IEEE P802.3bt PSE State Diagram Update

Dan Dove, DNS for LTC

July 10, 2015

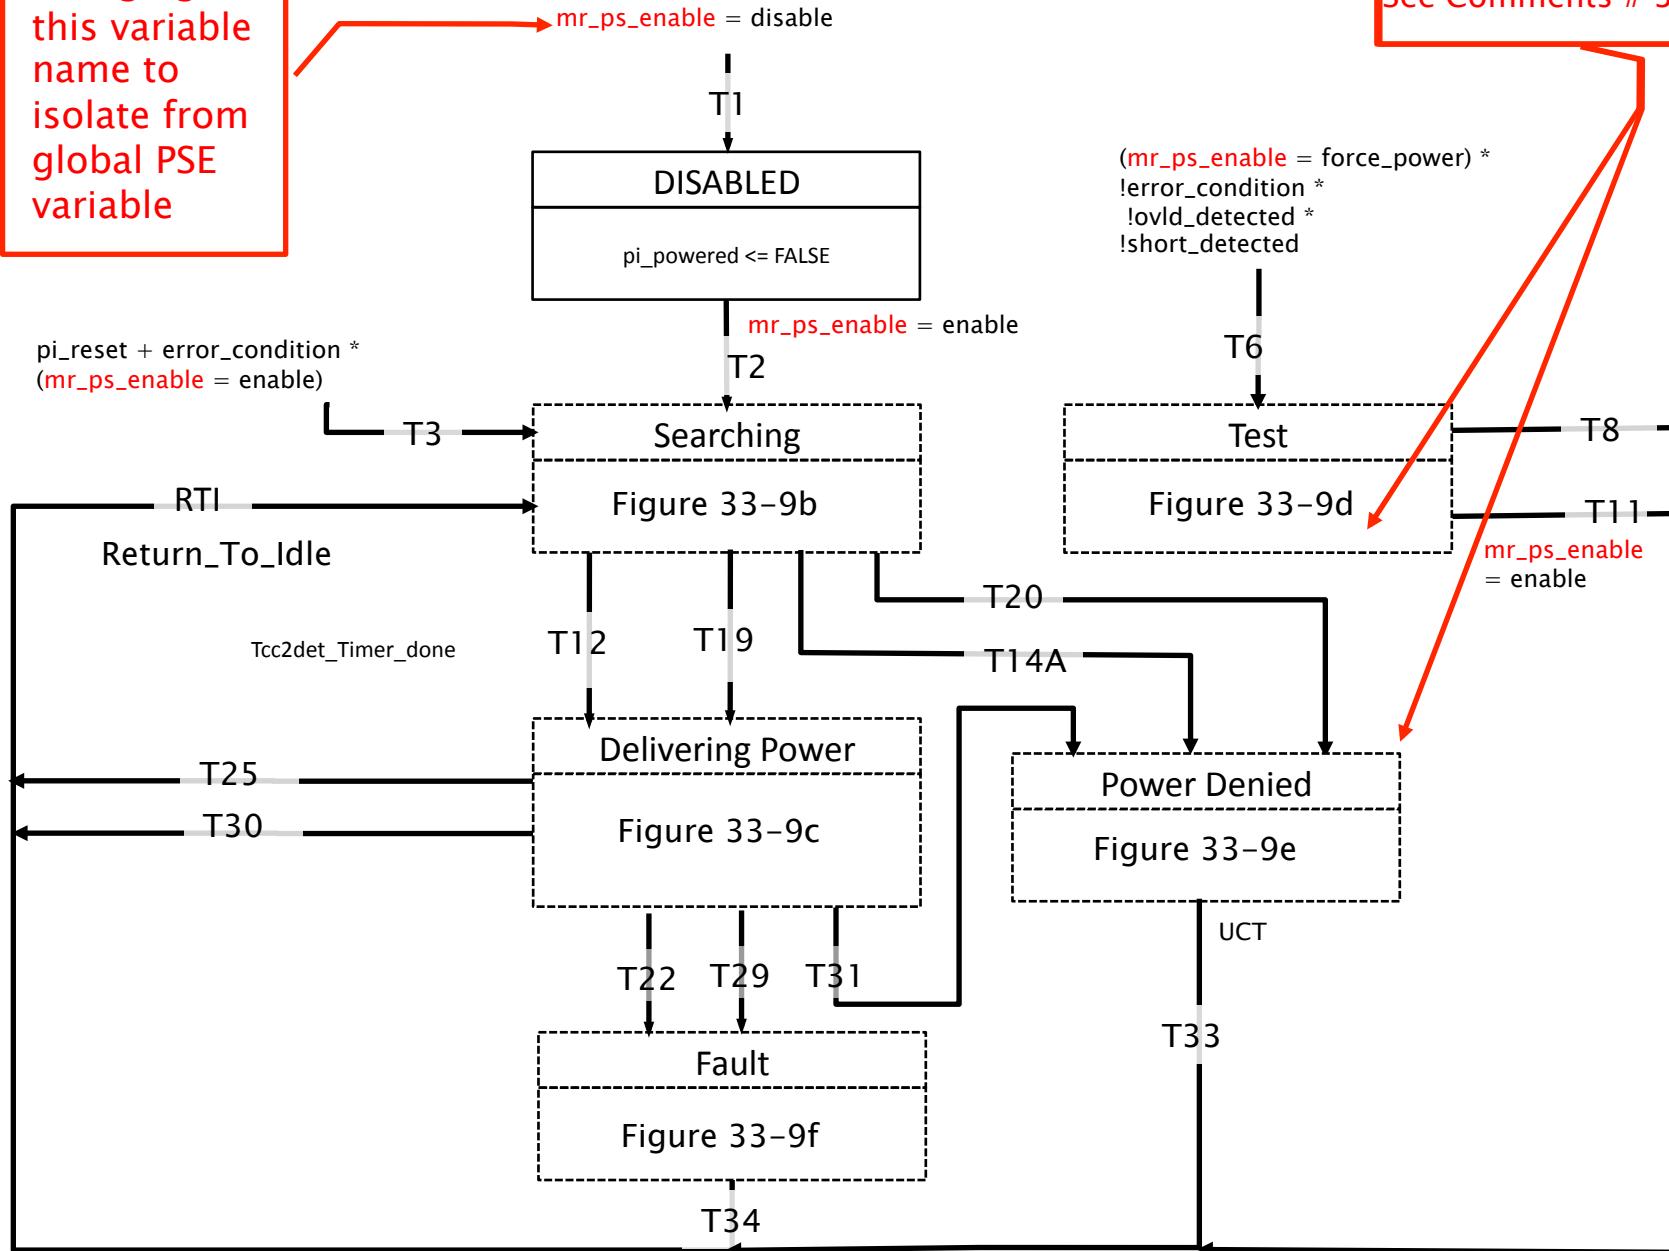
Note: For dual capable PSEs with dual-signature PDs, this diagram indicates the PSE will operate as two distinct Pair_Set_Control state machines with distinct variables for each.

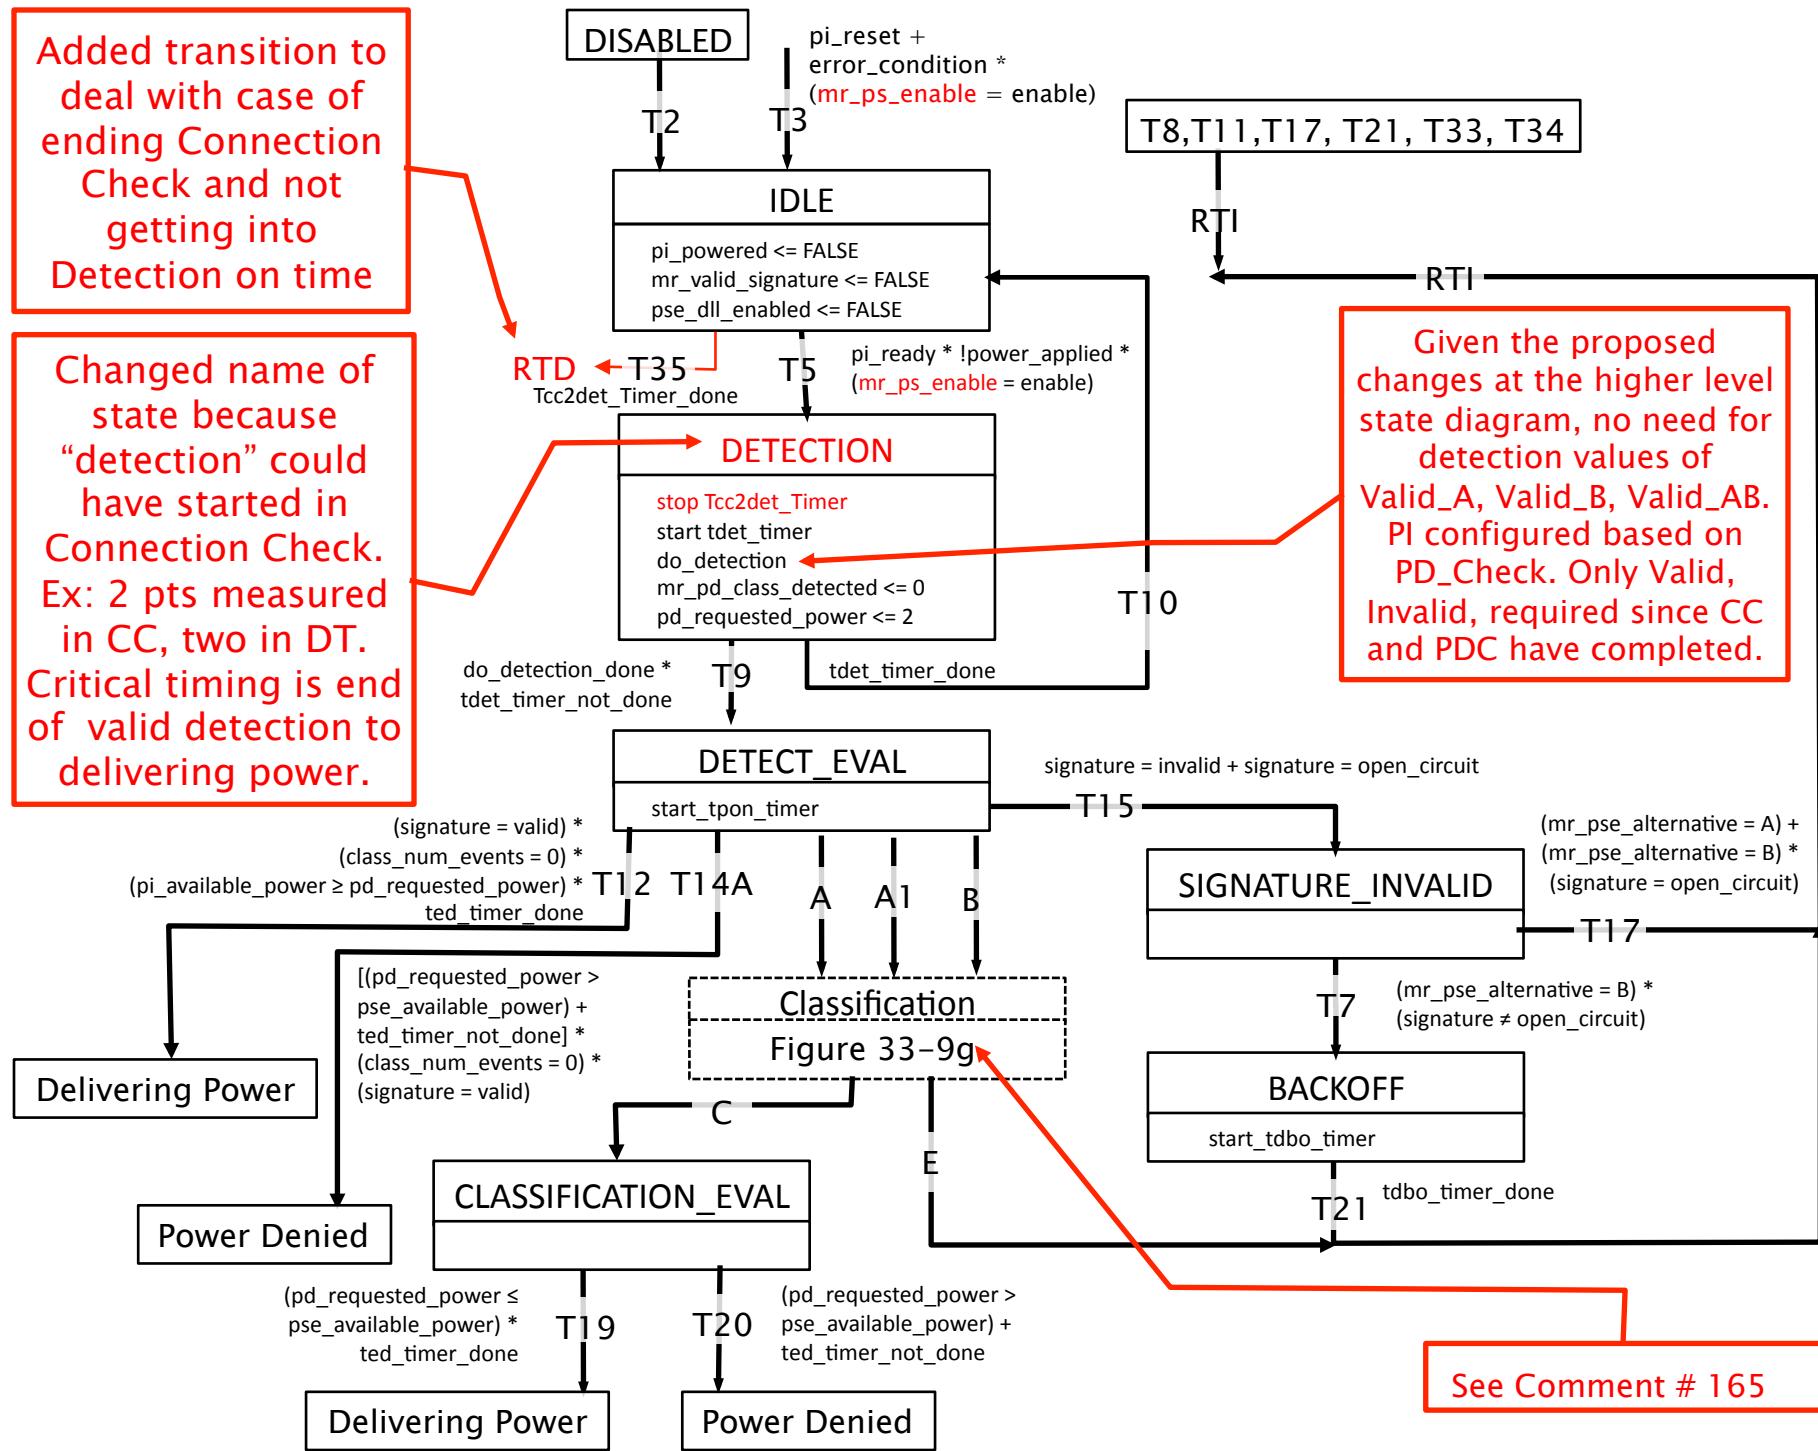
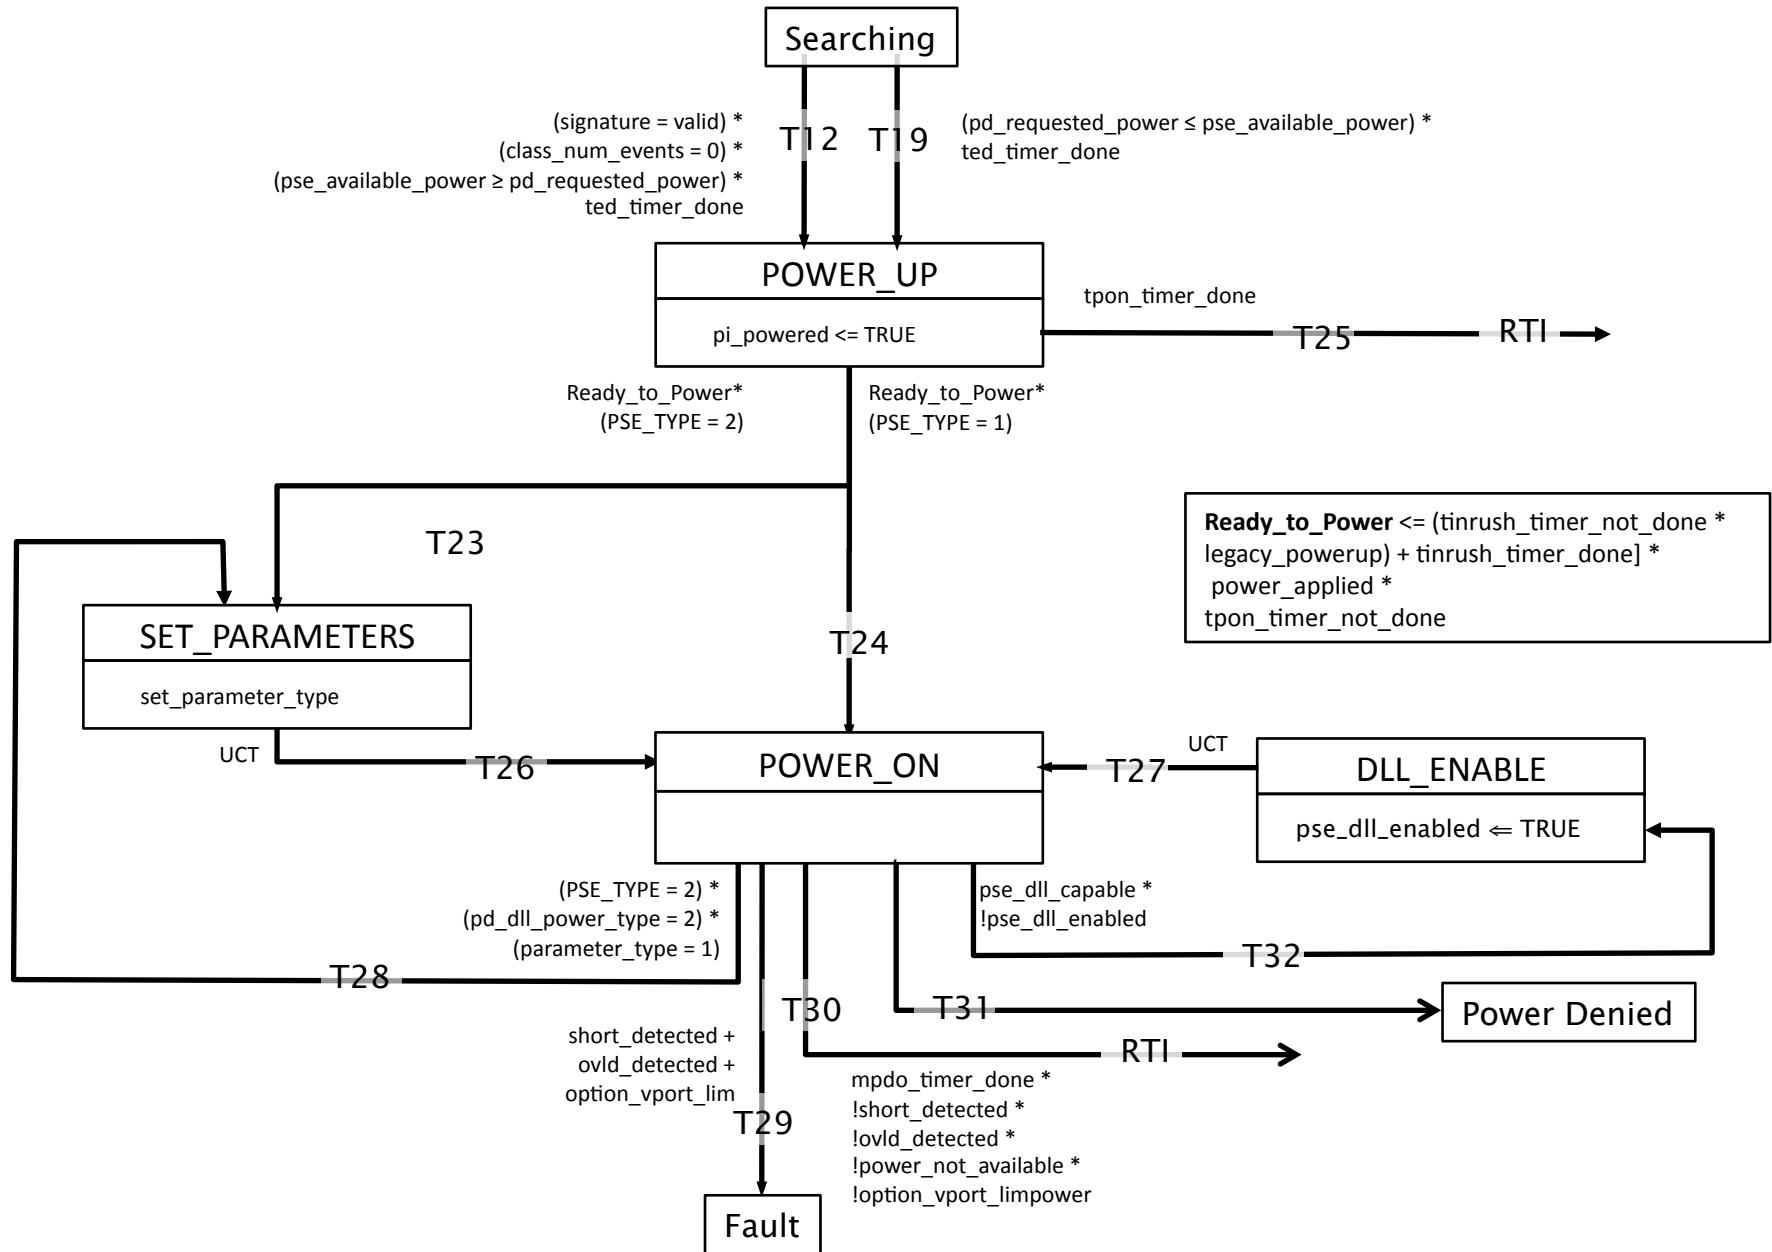
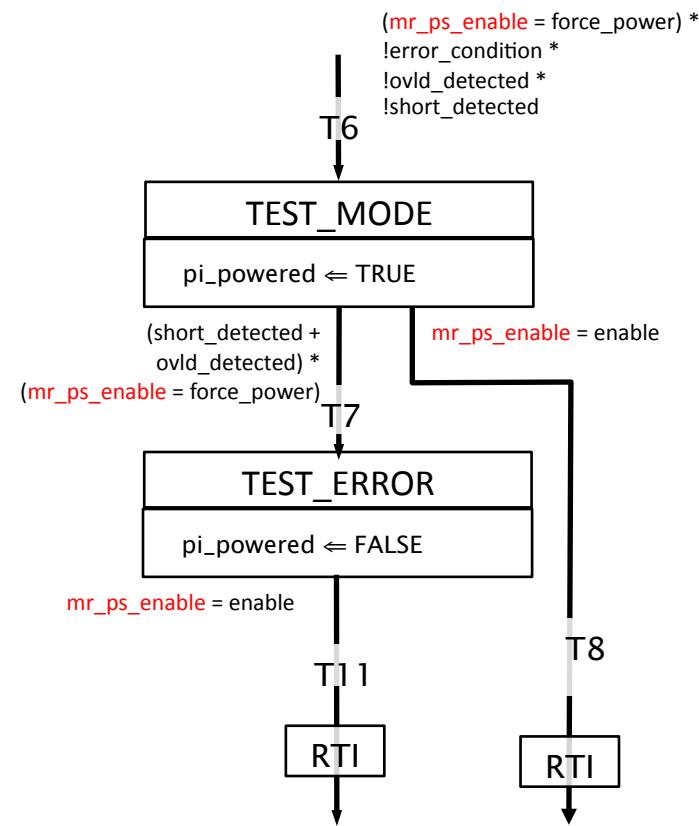
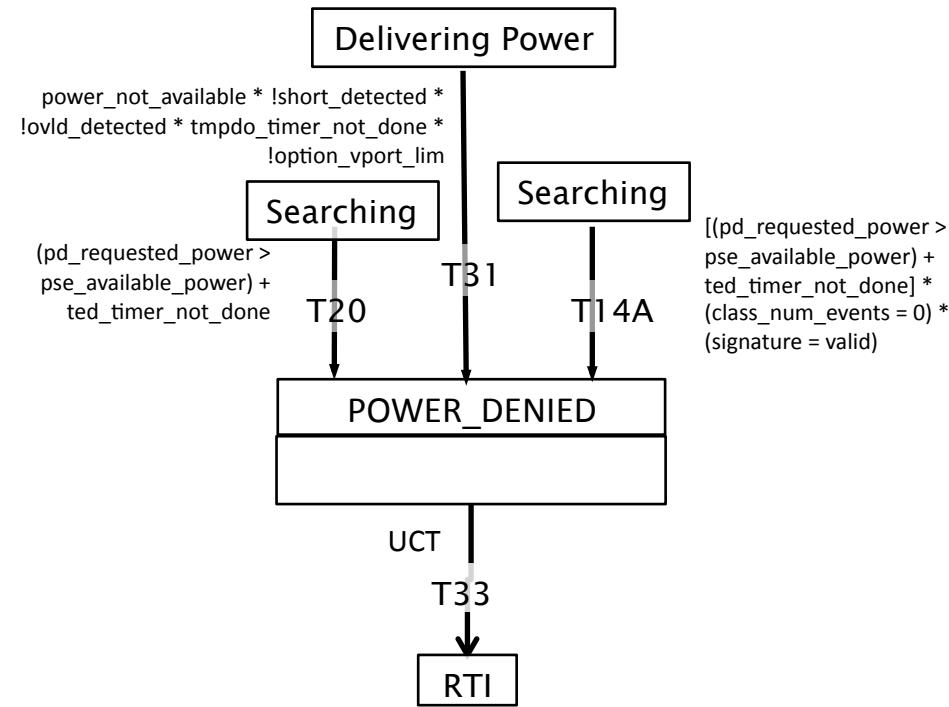
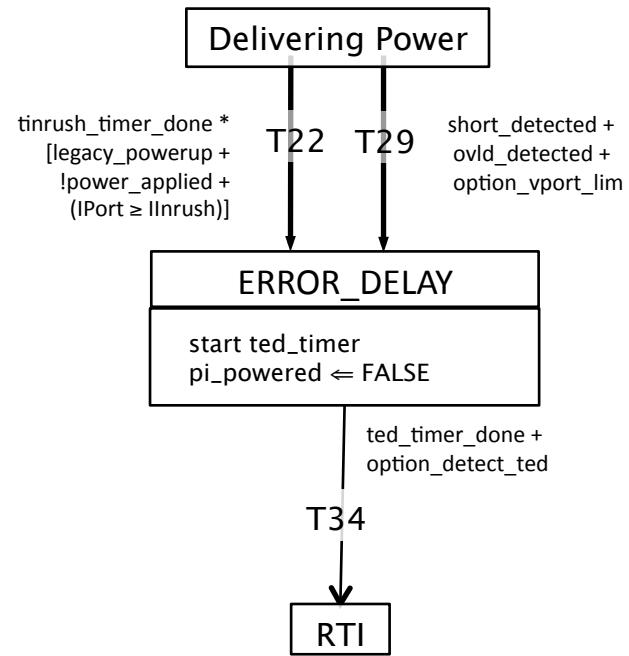
Requires changing this variable name to isolate from global PSE variable

Added transition to deal with case of ending Connection Check and not getting into Detection on time

Changed name of state because "detection" could have started in Connection Check. Ex: 2 pts measured in CC, two in DT. Critical timing is end of valid detection to delivering power.
